SERVICE Counselor

PACKARD DIVISION

STUDEBAKER-PACKARD CORPORATION

AUGUST, 1955

Engine Runaway— Low to High Shifts

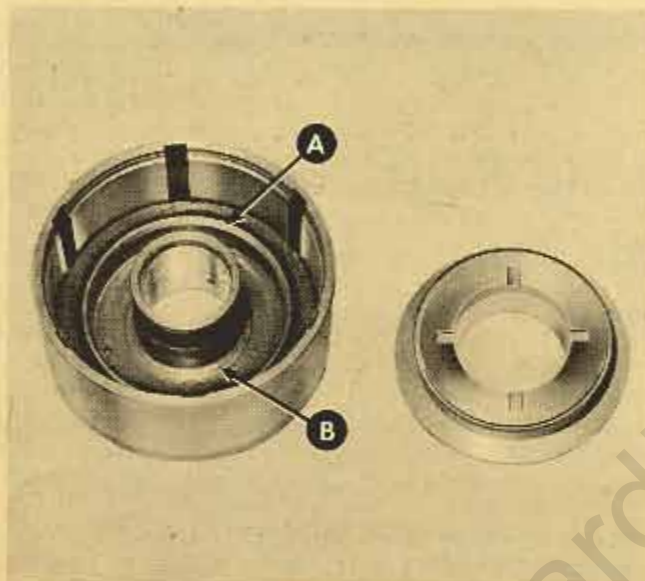
In some instances, it has been found that the high range clutch piston in the released position rests on the milled surface indicated by "B" in the illustration restricting the oil pressure to the back of the piston causing slow engagement of the clutch.

When the piston is in its released position, the flange on the piston should rest on the shoulder "A" in the high range clutch housing, leaving .031" clearance between the end of the piston and the milled surface marked "B" which provides a means for the oil pressure to engage the clutch.

If the piston is found to be touching or resting on the milled surface "B" in the clutch housing, oil passages can be provided by filing four grooves in the piston as shown.

Using the edge of a 12" file, carefully file four grooves equally spaced 1/16" deep and 1/4" outward from the chamfered center hole in the piston.

Horn Button Contact

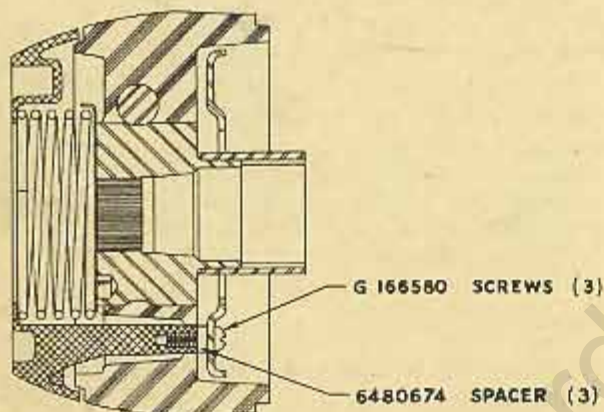
A few reports have been received of the horn button not making contact when the horn ring is pushed down at the location in line with the spoke of the steering wheel.

This condition can be corrected by installing spacers and longer screws between the steering wheel and the horn ring contact plate as follows:

2. Remove the three screws that attaches the contact plate to the steering wheel, install the three spacers No. 6480674 behind the plate and secure the plate with the three new longer screws No. G-166580. "See illustration."
